ETOD Detailed Site Plan
Departure from Parking and Loading Spaces
Tribeca at Camp Springs - Day Care Center

DSP-05018-01
DPLS-491

SUBJECT: Detailed Site Plan DSP-05018-01
Departures from the Number of Parking and Loading Spaces Required DPLS-491
Tribeca at Camp Springs - Day Care Center for Children
Expedited Transit-Oriented Development (ETOD) Project

1 OUTDOOR PLAY AREA DETAIL PLAN
SCALE 1" = 10'

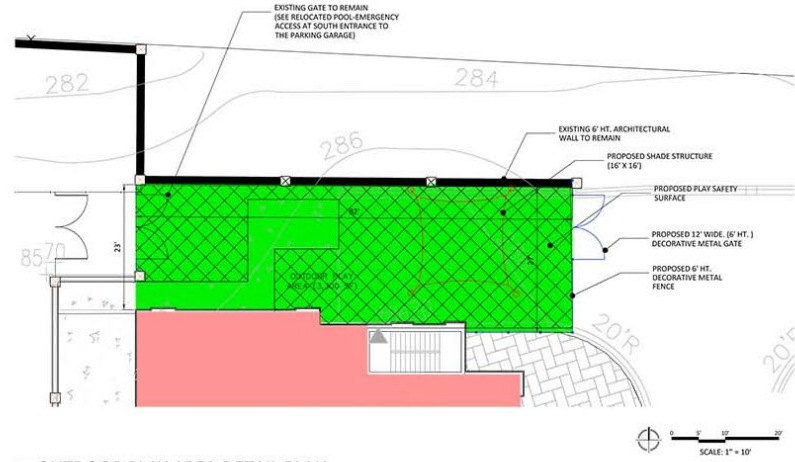
A removable shade structure for outdoor use will provide shade during the warmer months of the year within the play area. In addition, the adjacent building and architectural wall will provide shade at certain times of the day.

Per the applicant, the time period of outdoor play area usage will match that of the operational hours of the day care facility. The play time is limited to the hours between 7 AM and 9 PM. A site plan note to this effect should be added to the DSP, as conditioned herein.

SIGNAGE

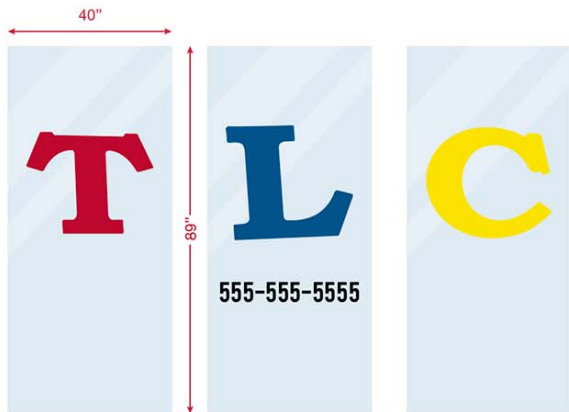
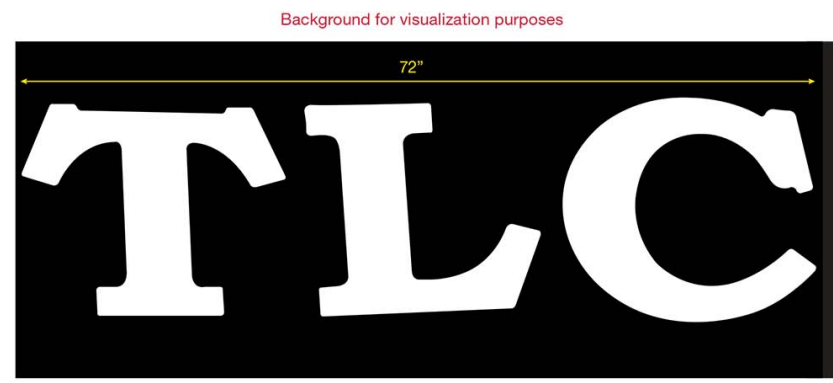
Building-mounted signage in the commercial zones (except for Commercial Office Zone) is determined by the length of the tenant space; however, the total square footage of the allowable signage increases with the number of the stories. For this five-story building, the proposed total sign face area should be within the permitted amount. However, the applicant should provide a signage table to list what is the permitted and what is the provided sign face areas. A condition has been included in the Recommendation section of this report requiring the applicant to provide such information, prior to certification of this DSP.

1. The site plan shall be in compliance with DSP-05018.
2. The dimensions of the (7) provided parking spaces for the day care shall be provided on the site plan.
3. Provide the tabulation, including the building frontage, showing what is allowed for the proposed daycare building signs.
